## ADDENDUM #2

Date: 07/01/2024

Project: Reroofing Project for the  
Merrillville Community School Corporation  
6701 Delaware Street  
Merrillville, Indiana 46410  
Architect's Project # 24013

SHEET  
**A**  
3.1.4

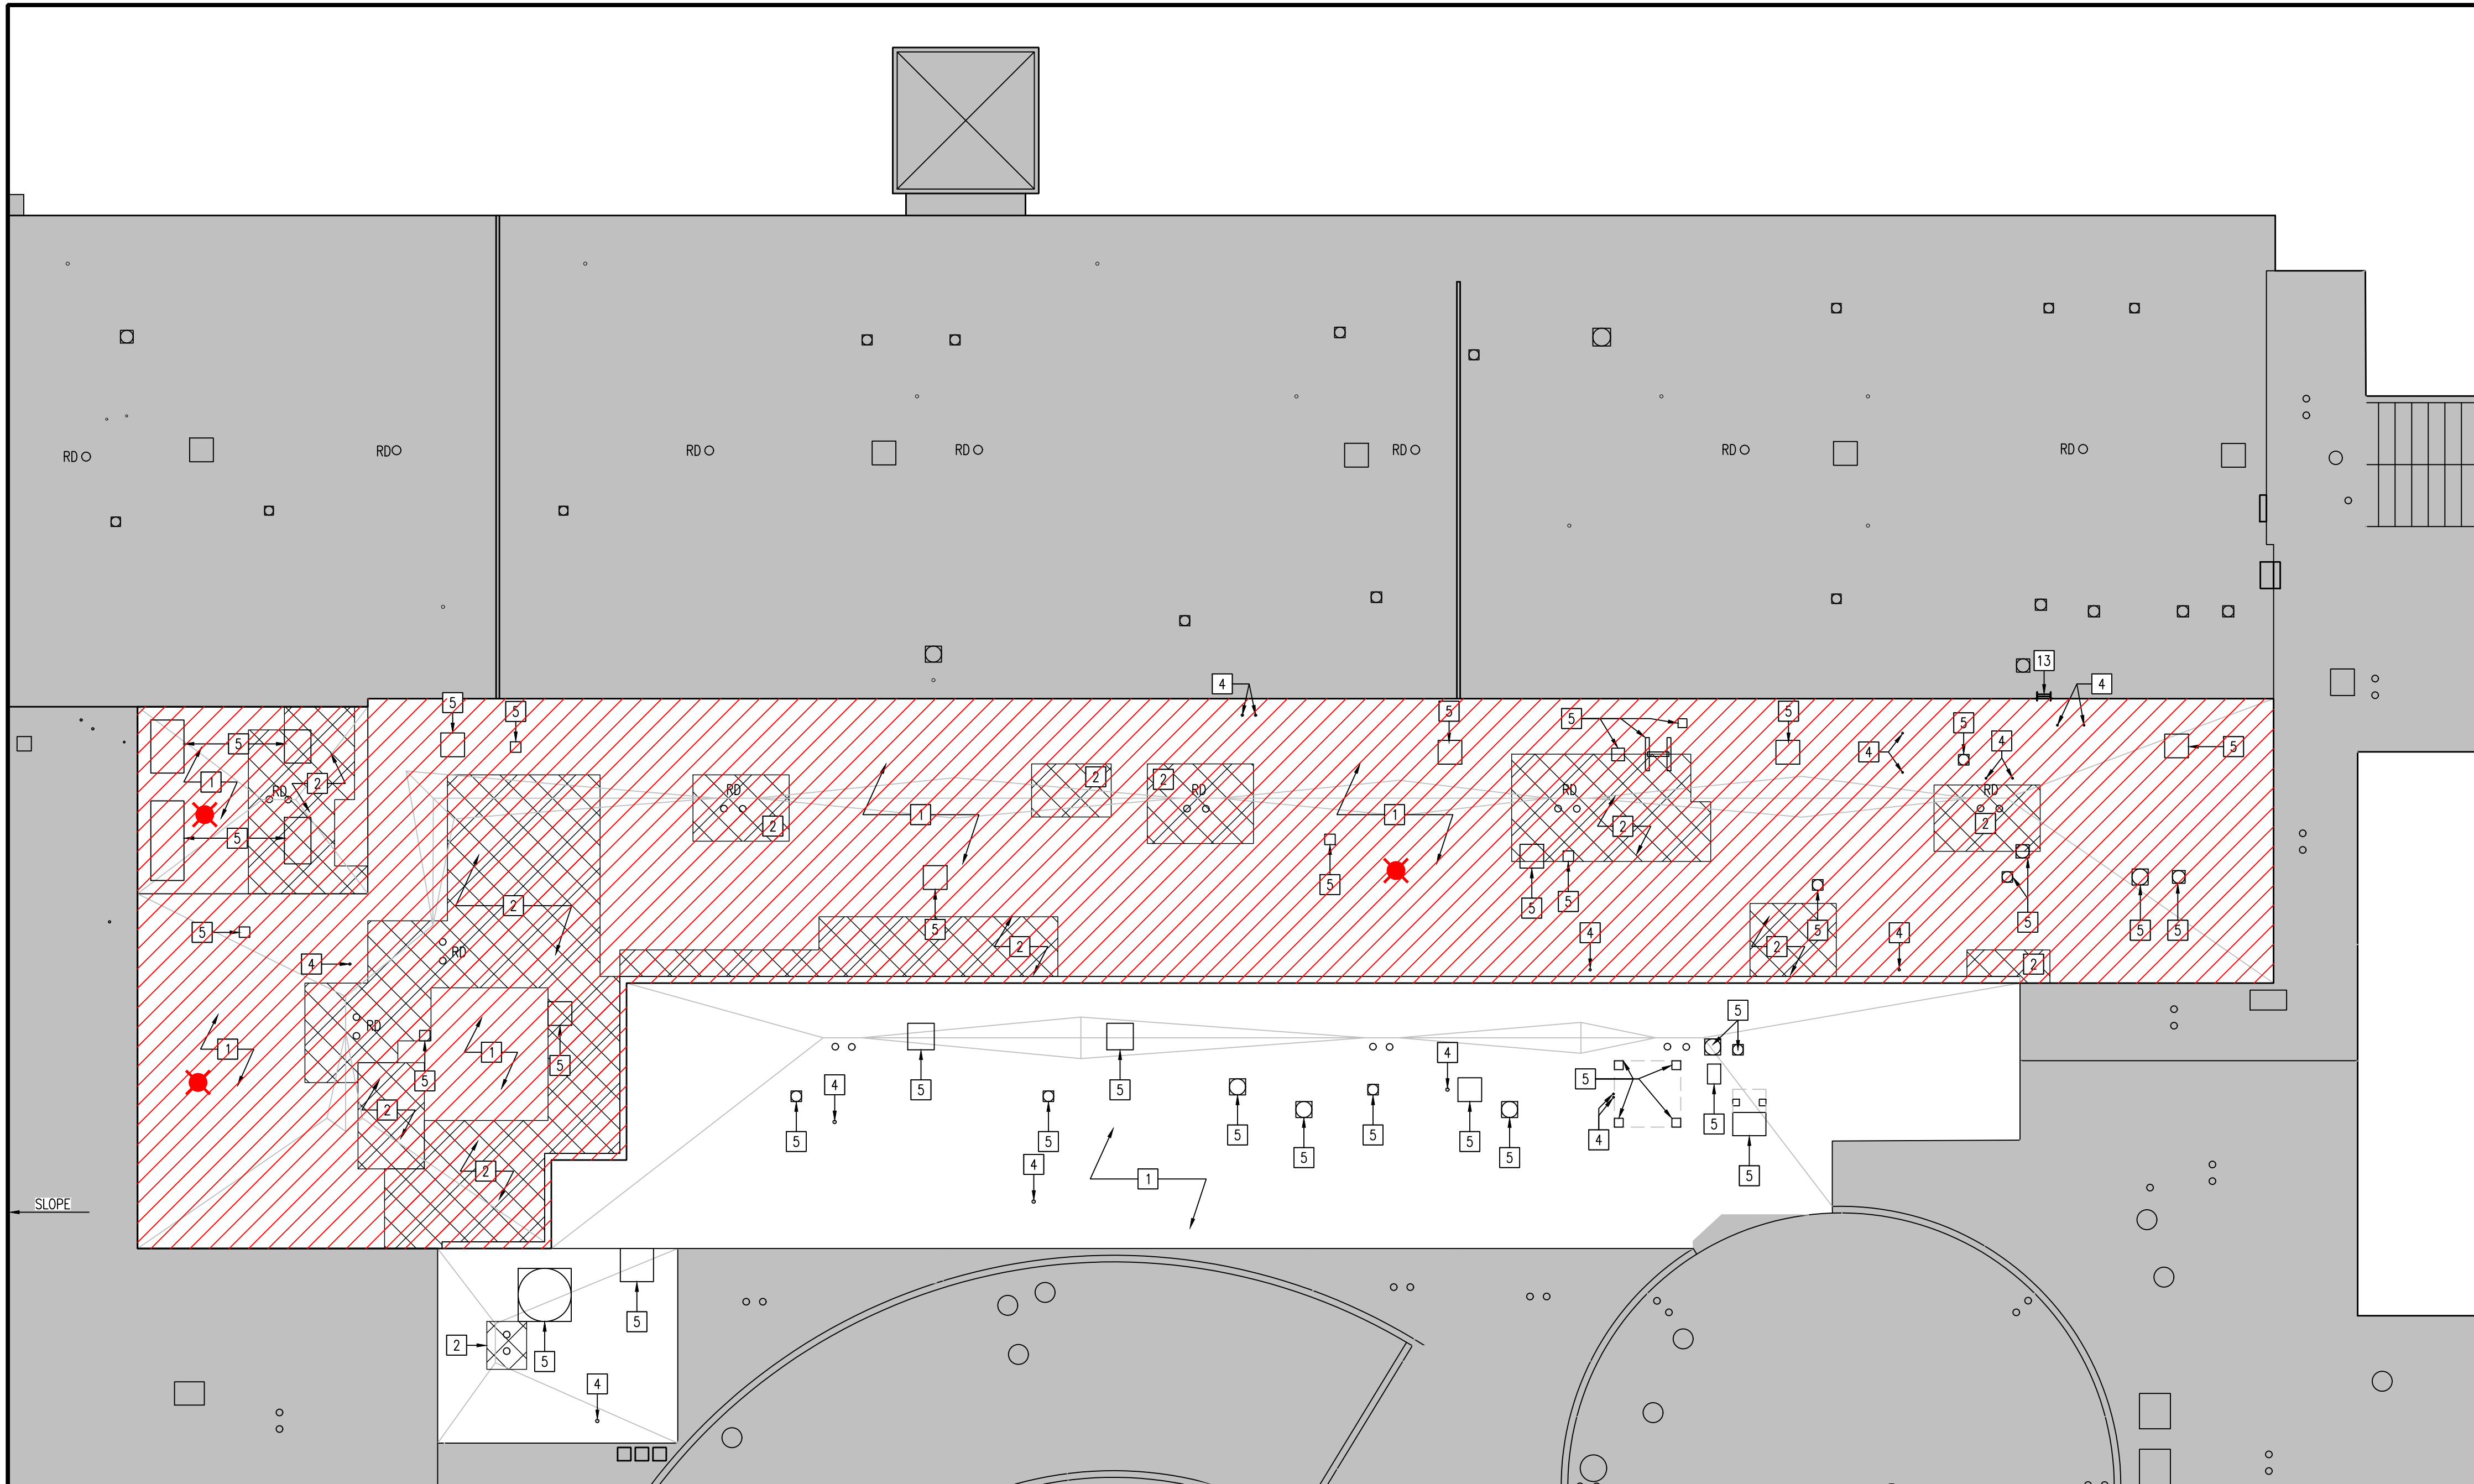
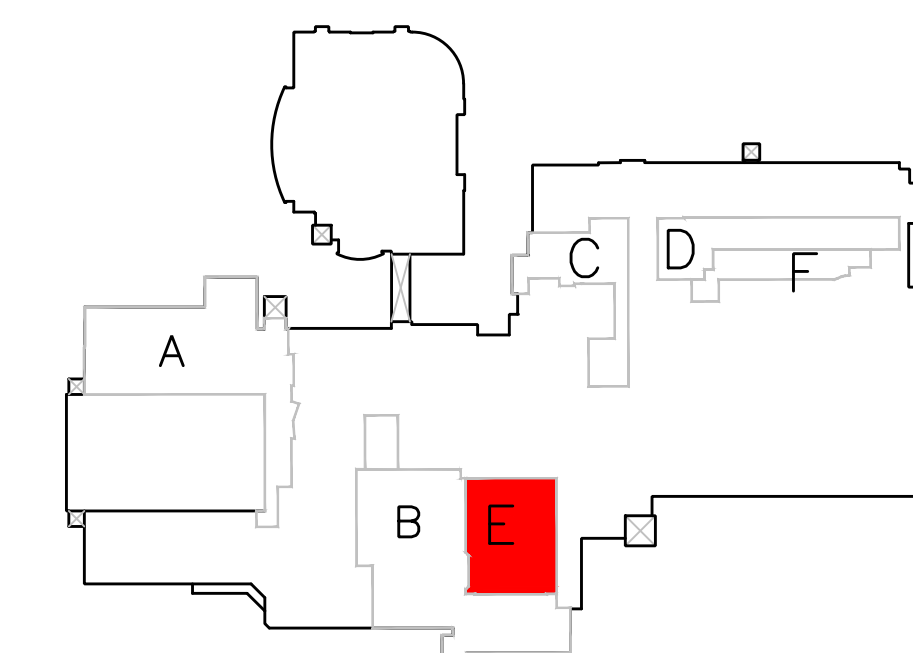
5. See attached Revised Drawing Sheet A3.1.3 – Partial Roof Plan – Area D – This plan shows clouded and tagged revisions dated 07/01/2024.
6. See attached Revised Drawing Sheet A3.1.4 – Partial Roof Plan – Area E – This plan shows clouded and tagged revisions dated 07/01/2024.

SHEET  
A  
3.2.0

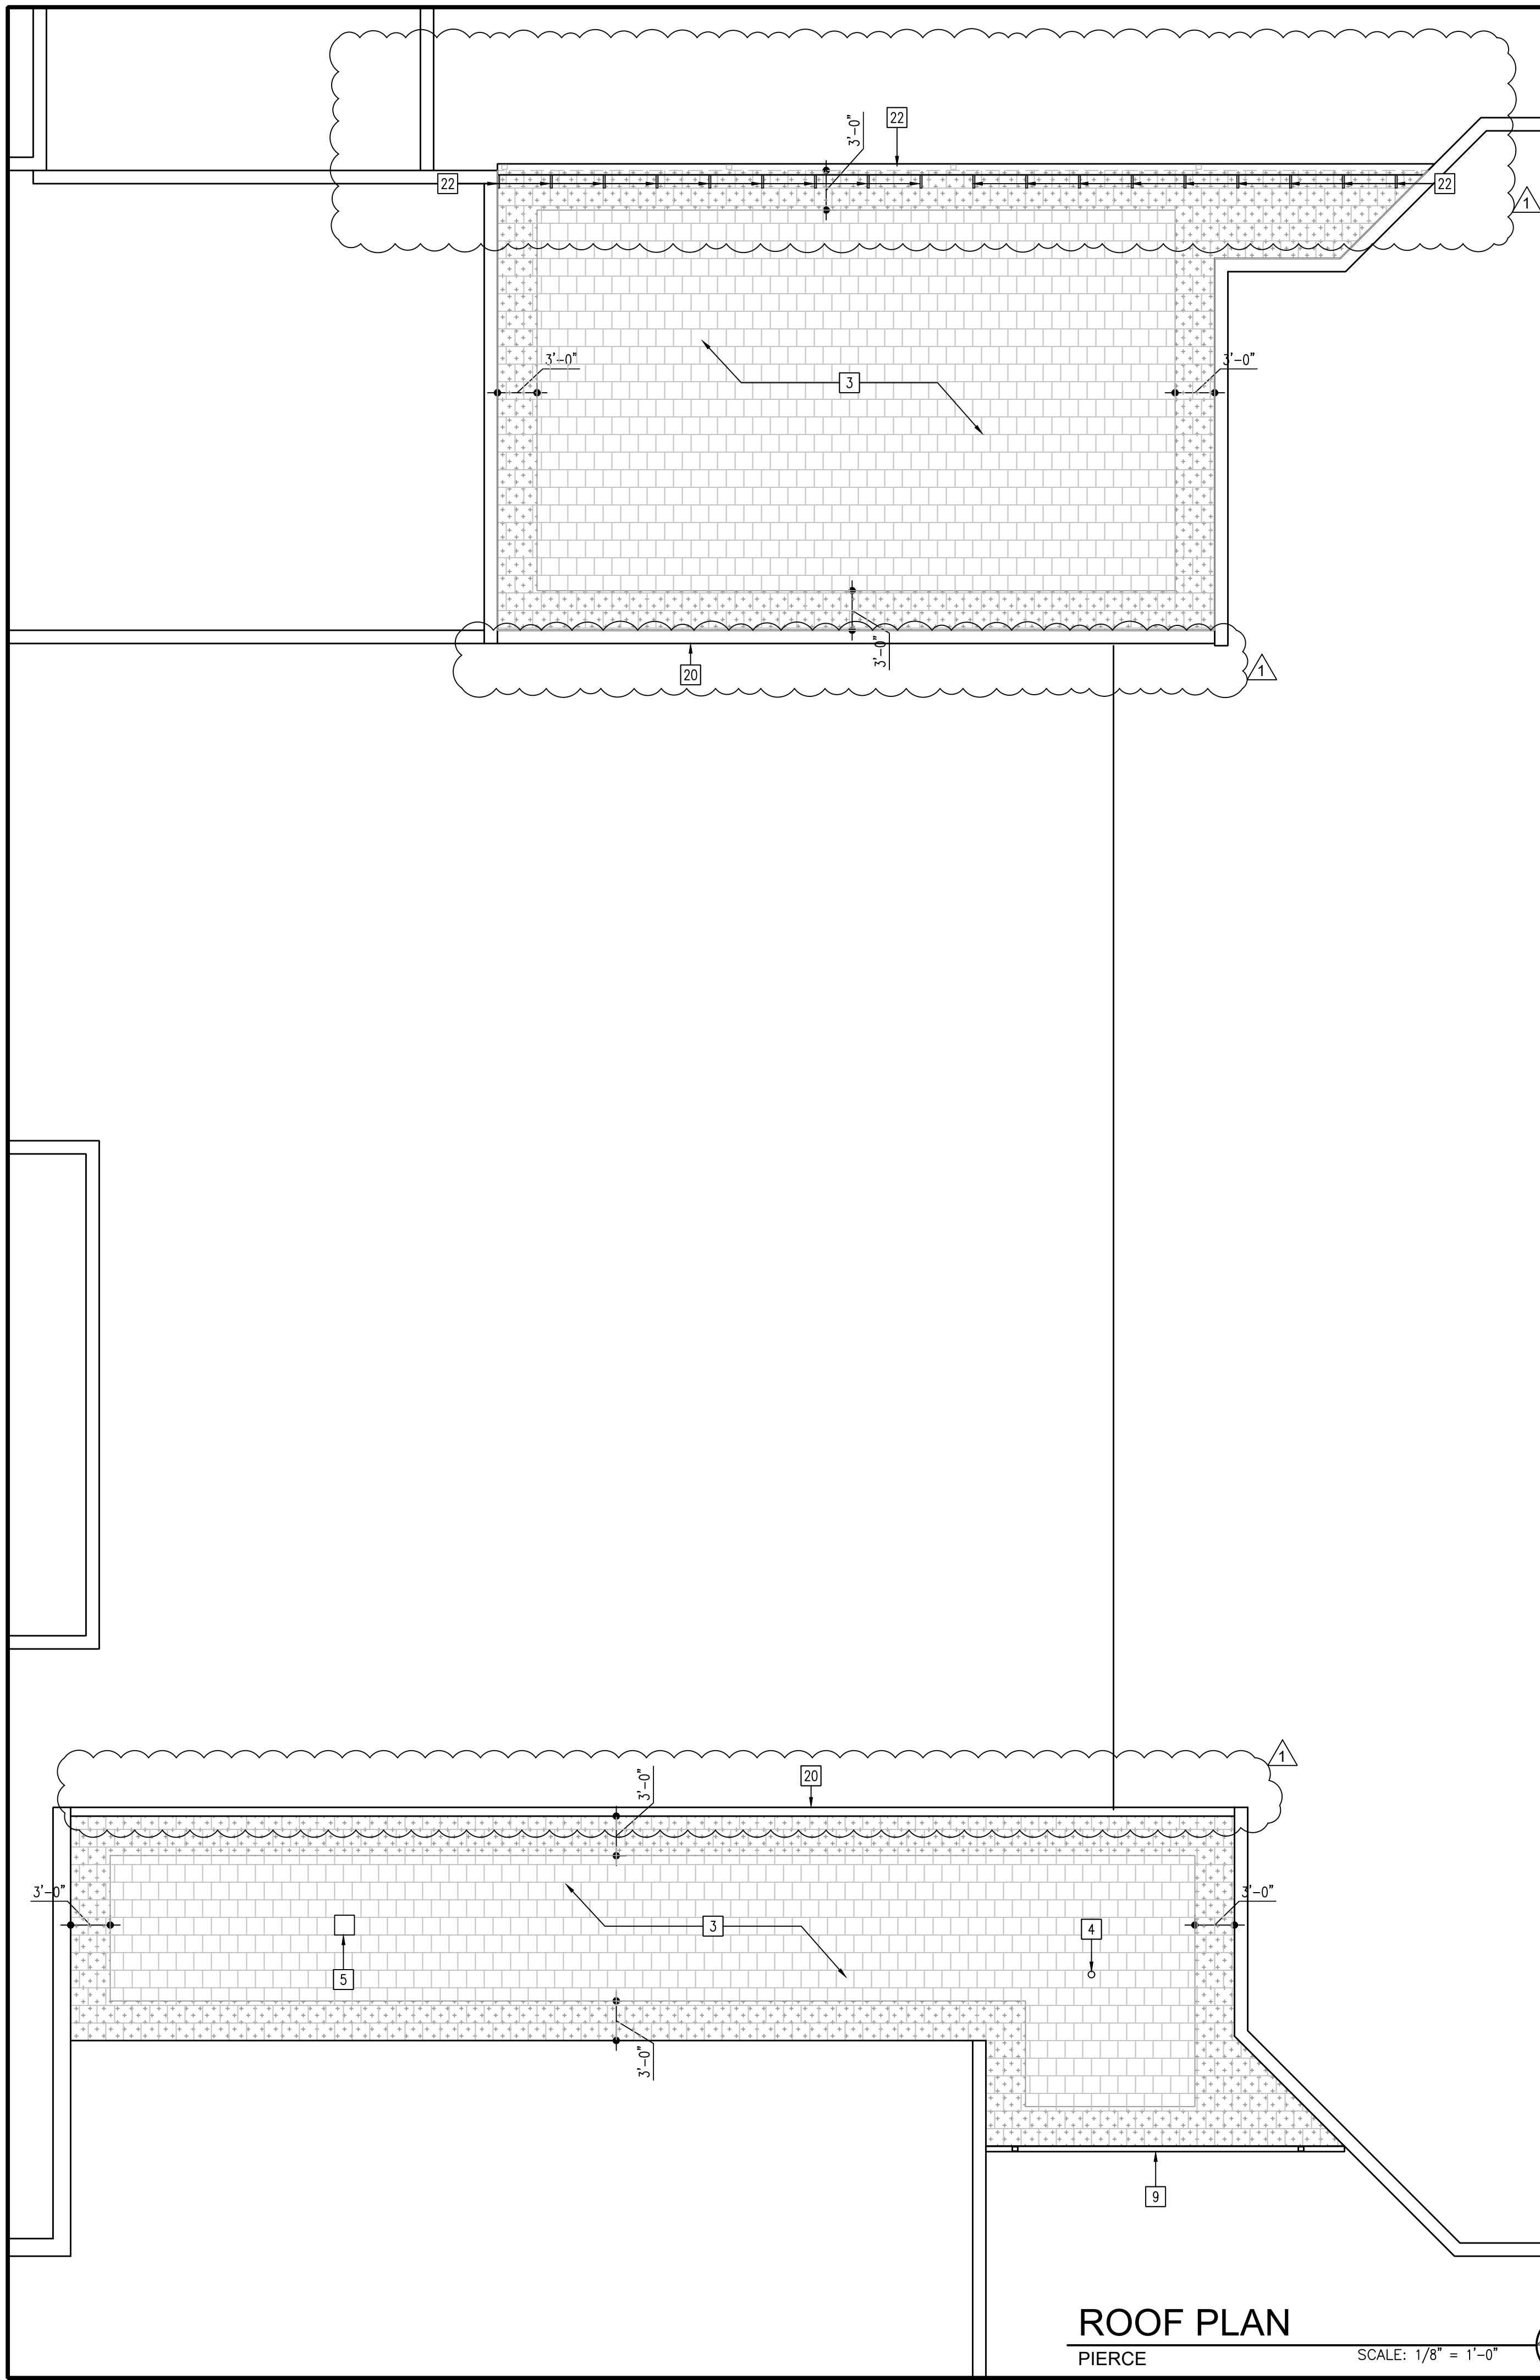
7. See attached Drawing Sheet A3.1.5 – Partial Roof Plan – Area F – dated 07/01/2024. This drawing is being issued in its entirety.
8. See attached Revised Drawing Sheet A3.2.0 – Roof Plan – MHS Concession – This plan shows clouded and tagged revisions dated 07/01/2024.
